M00263.AR.000395
MCRD PARRIS ISLAND
5090.3a

EMAIL REGARDING U S EPA REGION IV COMMENT ON WORK PLAN FOR DIRECT PUSH WORK AT SITE 45 DRY CLEANING FACILITY SPILL AREA WITH ATTACHMENT MCRD PARRIS ISLAND SC
2/10/2006
U S EPA REGION IV

DRAWN BY C. SPEHAR	DATE 01/06/06	PROPOSED TW AND PW LOCS FOR SUPPLEMENTAL INVESTIGATION LOWER SURFICIAL PLUME WITH MIPS OVERLAY SWMU 45 - MWR DRY CLEANING FACILITY RI/RFI ADDENDUM MCRD PARRIS ISLAND PARRIS ISLAND, SOUTH CAROLINA	CONTRACT NUMBER N5260
CHECKED BY	DATE		APPROVED BY / DATE
COST/SCHEDULE-AREA			APPROVED BY / DATE
SCALE AS NOTED	NAVFAC		DRAWING NO. FIGURE 1 / REV 0

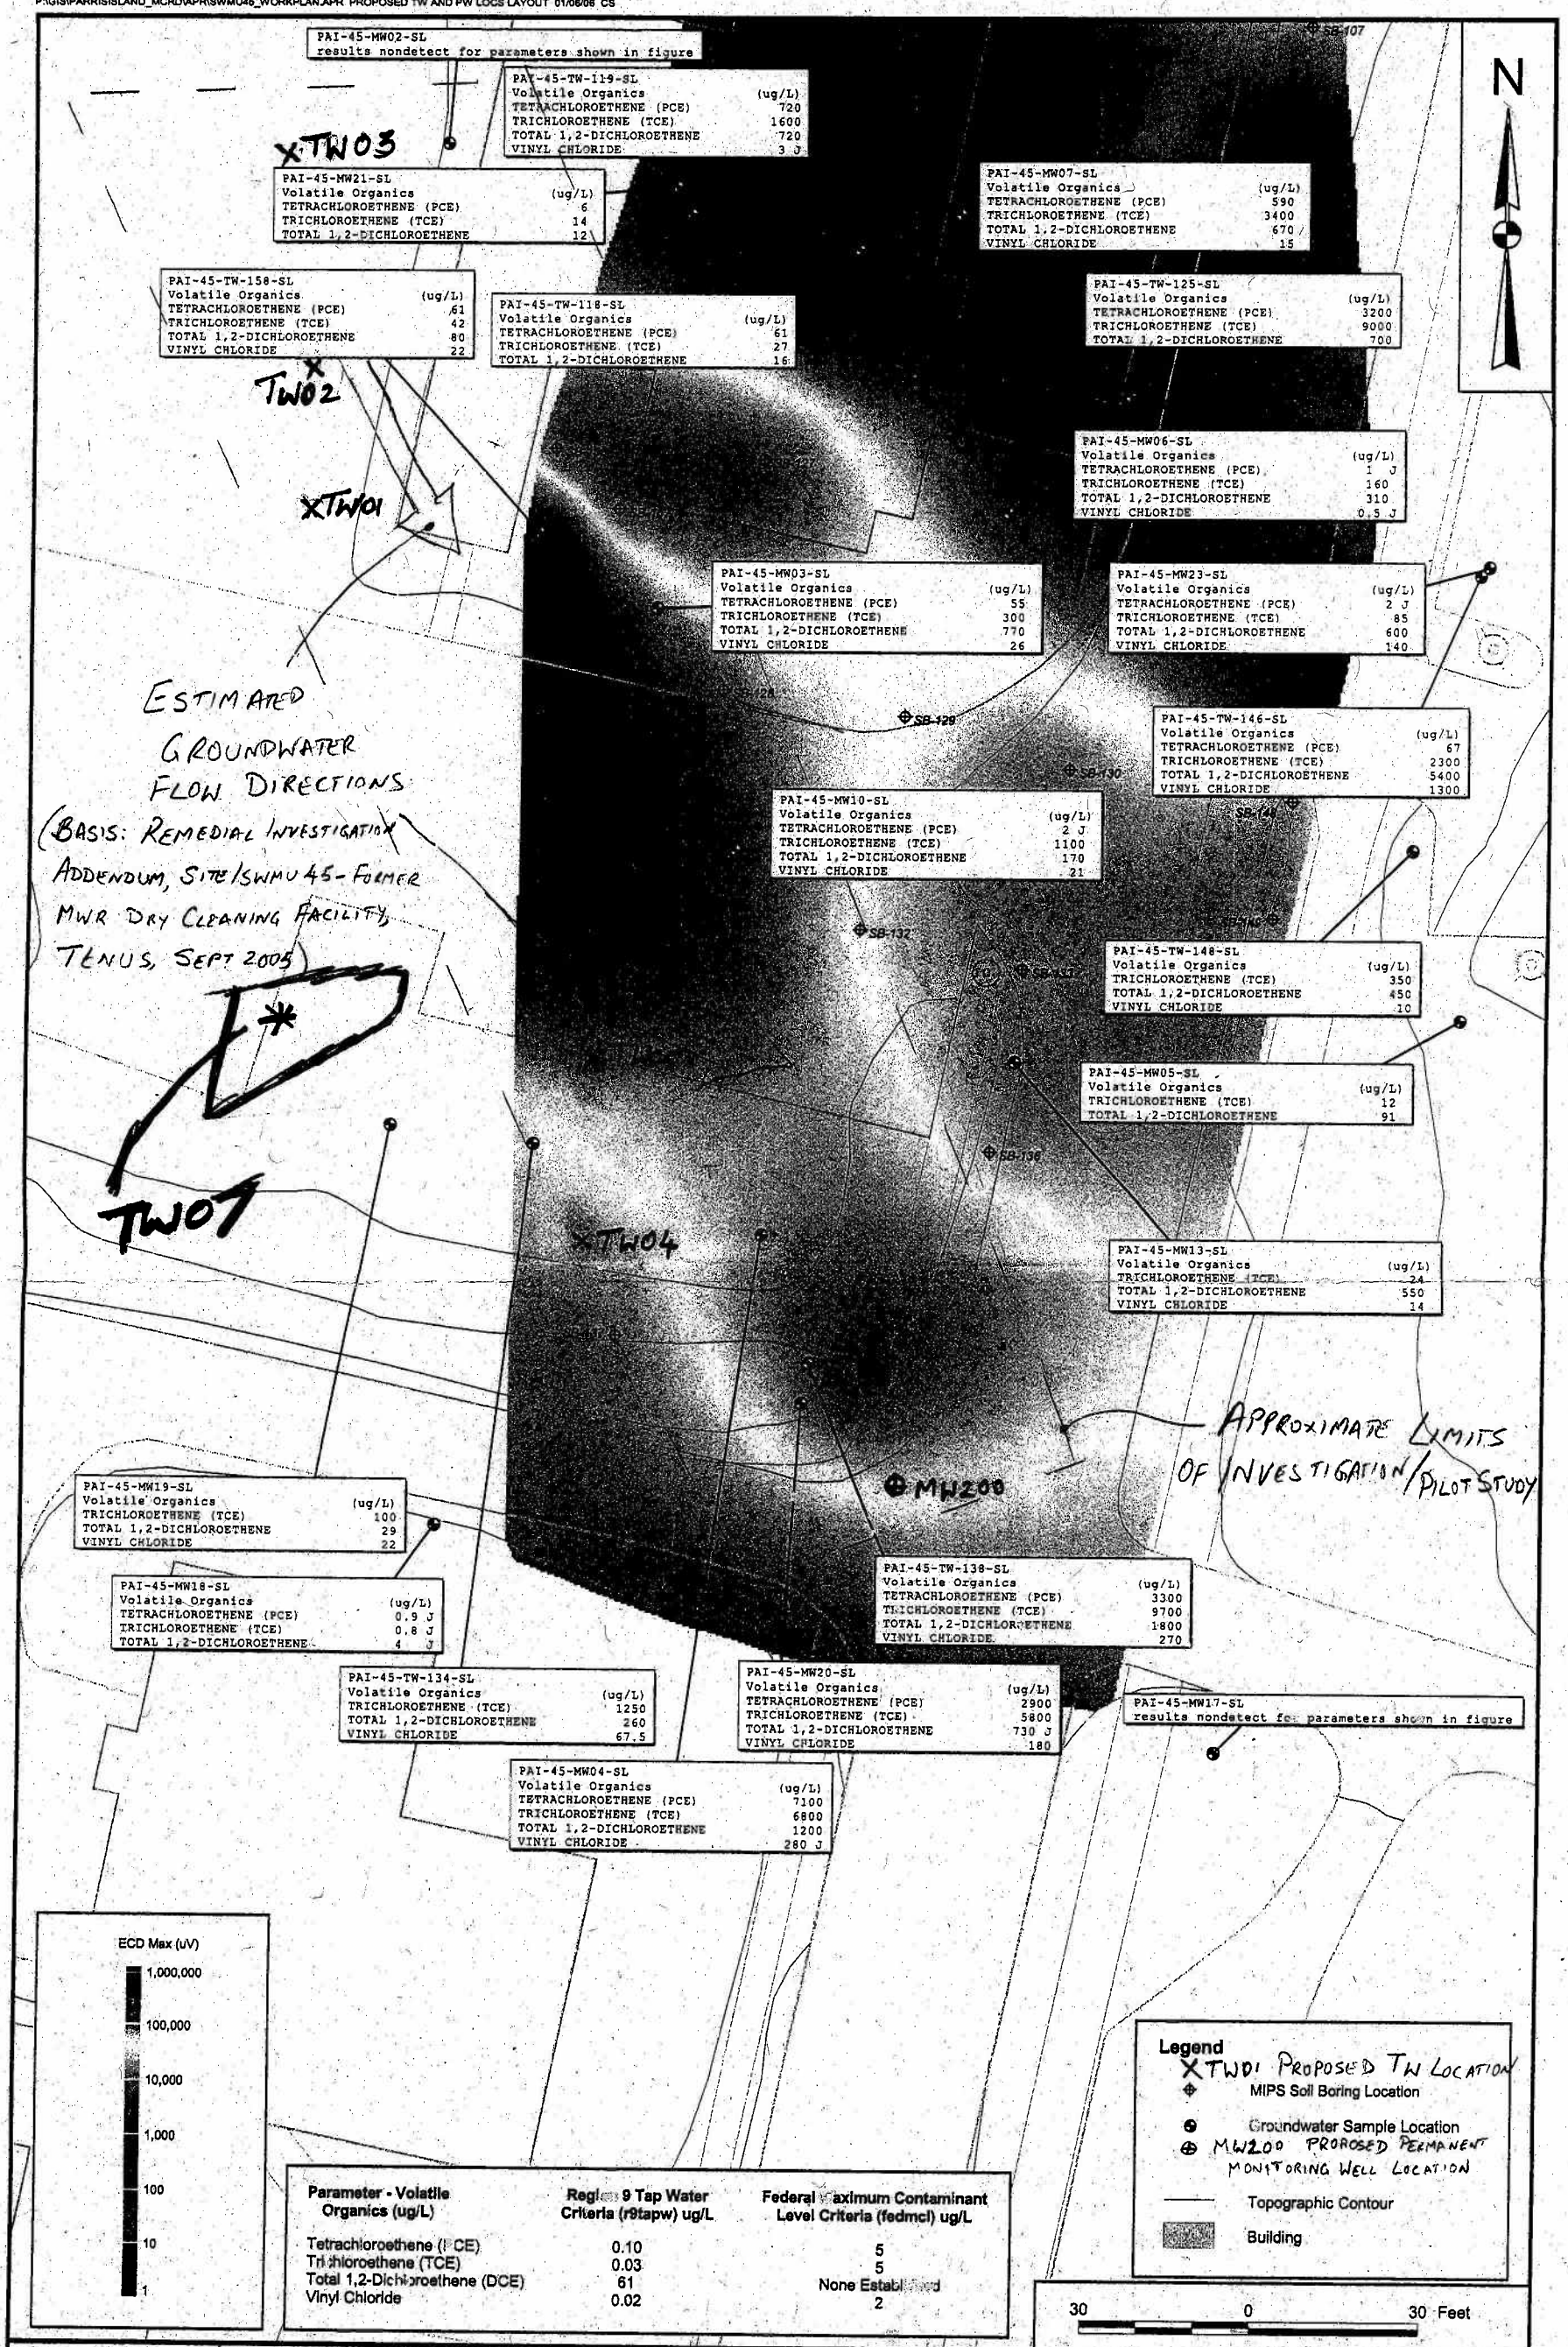
1) As reported, groundwater samples will be collected to verify the edge of contamination, or source area. The work plan does not address the data gap west of monitoring well PAI-45-MW19-SL. Please address this area.

Stan - Though we weren't really looking for any comments from regulators, EPA did provide the comment below on our current work at MCRD Parris Island. It is probably easy enough to comply, and the area described by EPA actually is near our study area - see attached map. Please see if you can install an additional temp well as shown on attached figure. The TW can be anywhere in the triangle I drew, depending on buried/overhead utilities. If temp well has positive detections from color-tek, then also move upgradient from this location, same as with temp wells 1-6. Tomorrow (Tuesday) is travel day. I'll get to the Hampton sometime after 4:00 PM if we need to discuss. I plan to call you today, in the afternoon when your flight lands, to review the same info as in this email. thanks
